# Sub Regional RTEP Committee: Western AMPT Supplemental Projects

November 18, 2022

# AMPT Projects in ATSI Transmission Zone M3 Process

# AMPT Projects in ATSI Transmission Zone: Supplemental Amherst, OH

Cancelation of Need: AMPT-2022-003

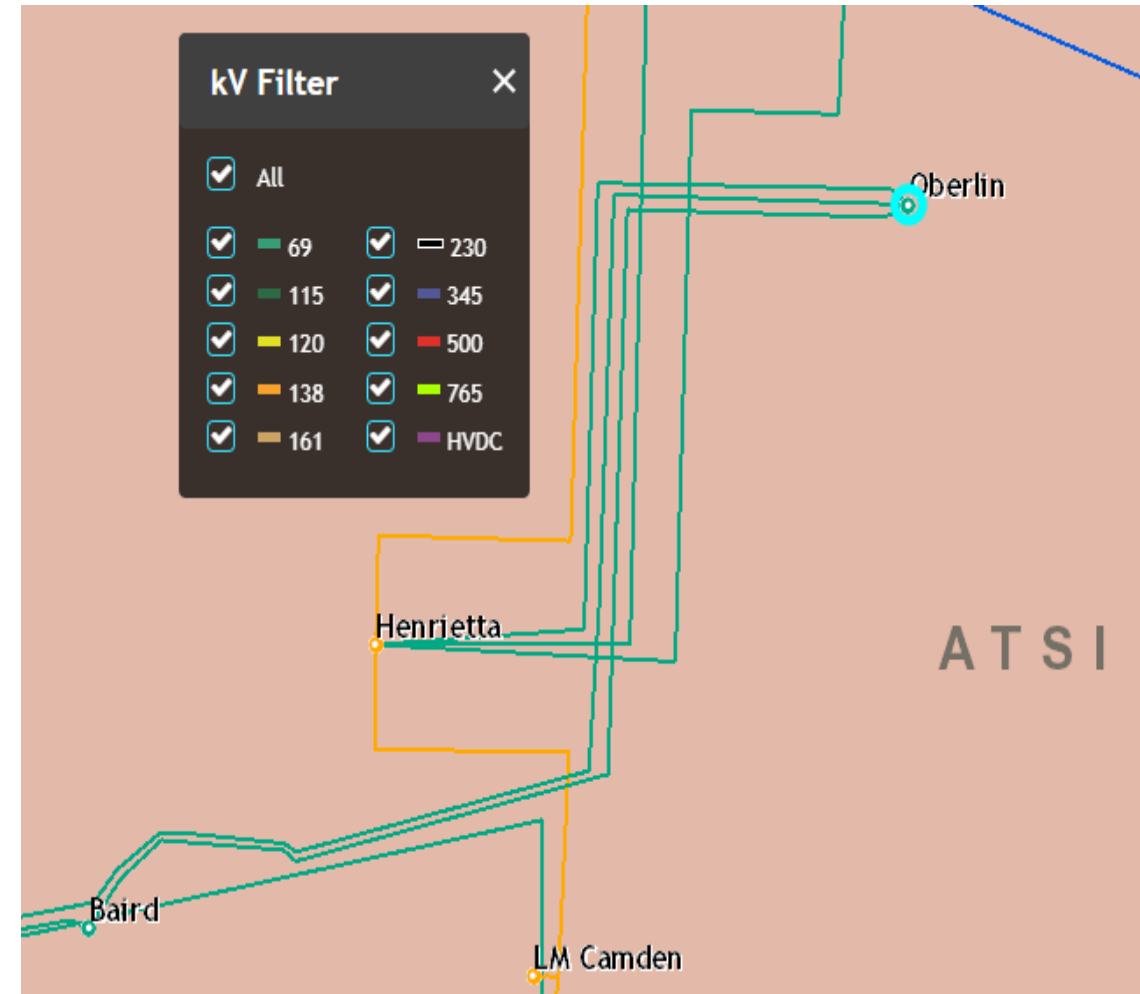
**Reason for Cancellation:** The City of Oberlin is working with ATSI to address the identified reliability concern.

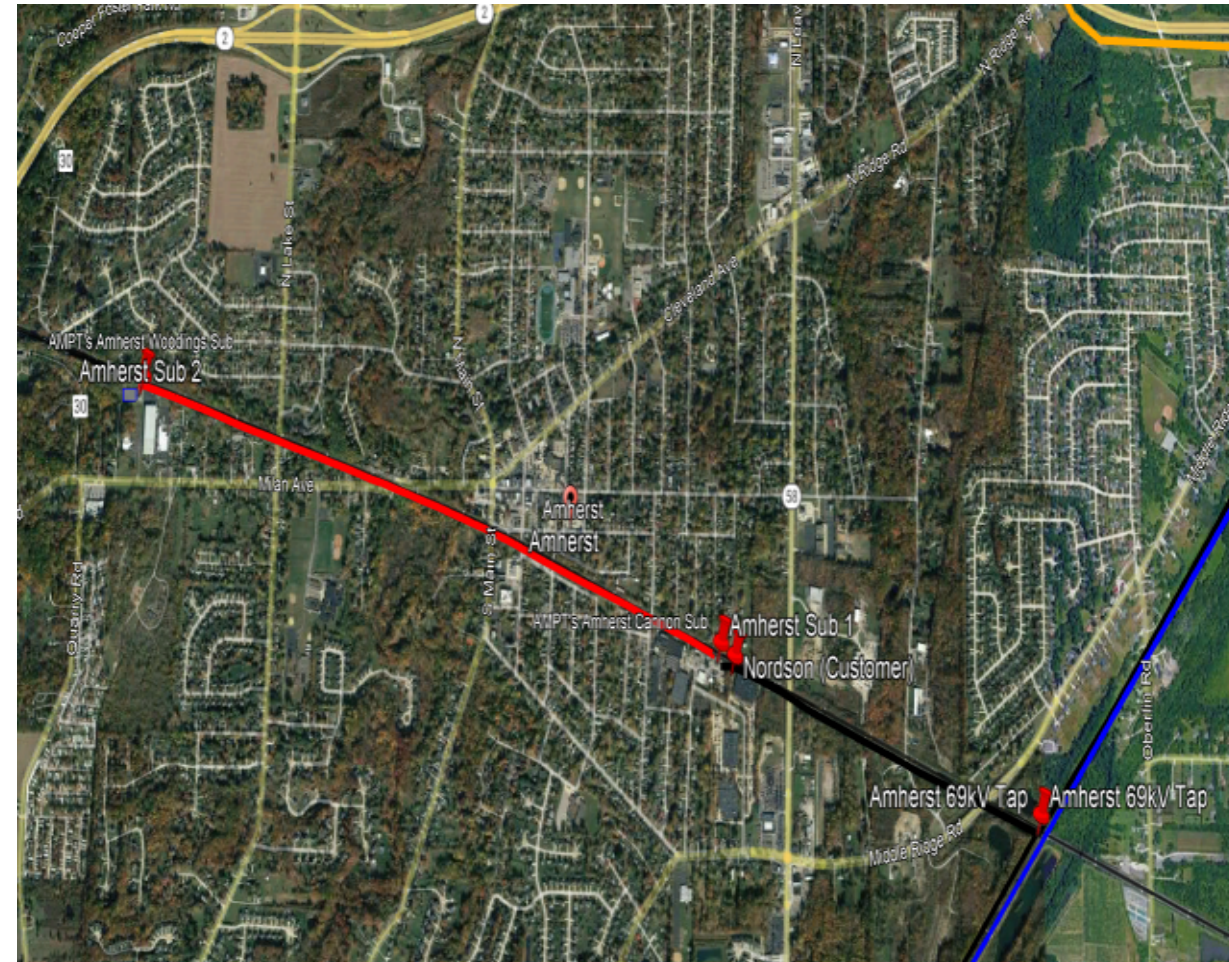
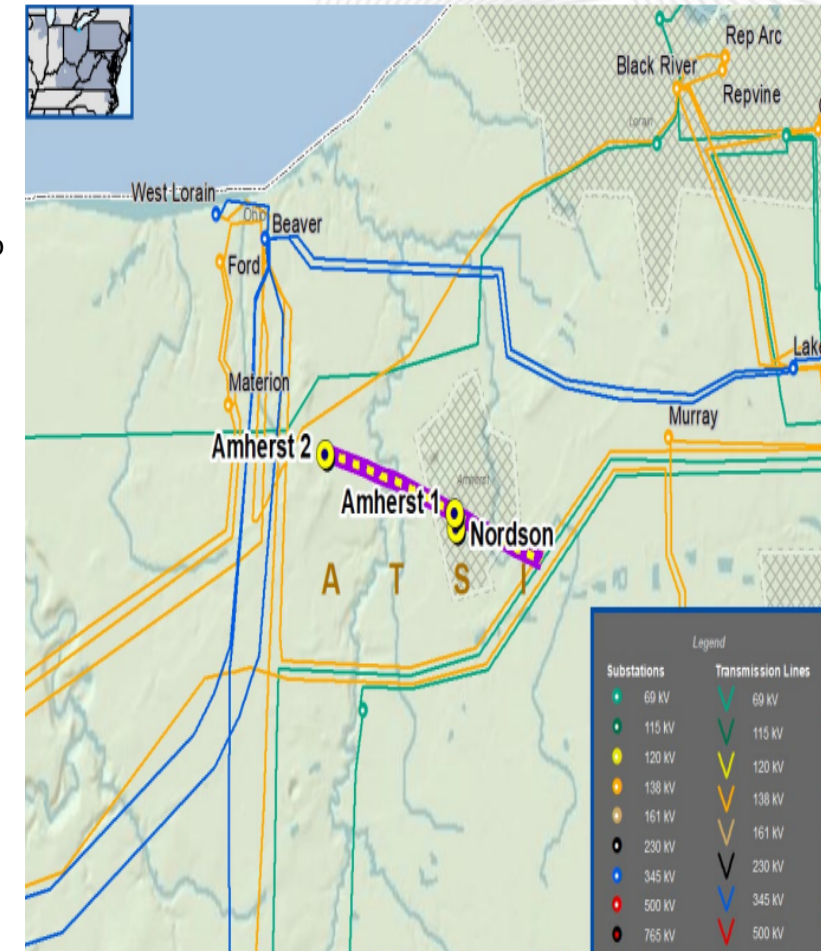
Design was adjusted to allow for a 50kA general Short Circuit Rating with breaker specifications being increased to 63kA. This required re-work of the transmission line design

- Construct a greenfield 138 kV double circuit line for approximately 0.4 miles using 954 54/7 kcmil ACSS conductor and tap into the existing Beaver-Black River (ATSI) 138 kV line. ~~(\$1.53 M)~~
- At Woodings (Amherst Sub #2) 69/12 kV Substation - Expand the sub with the installation of three (3) 138 kV circuit breakers; Install one (1) 138/69/12kV 130 MVA transformer; upgrade the 69 kV bus to 2000A, install two (2) 69 kV circuit breakers ~~(\$8.8 M)~~
- At Cannon (Sub #1) 69/12 kV Sub - Install one (1) 69 kV breaker towards Nordson; Replace 600A bus disc switch with one rated at 1200A ~~(\$0.92 M)~~

**Total Estimated Transmission Cost:** ~~\$11.25 M~~–~~\$16.8 M~~ (includes \$2.8M of FE scope)
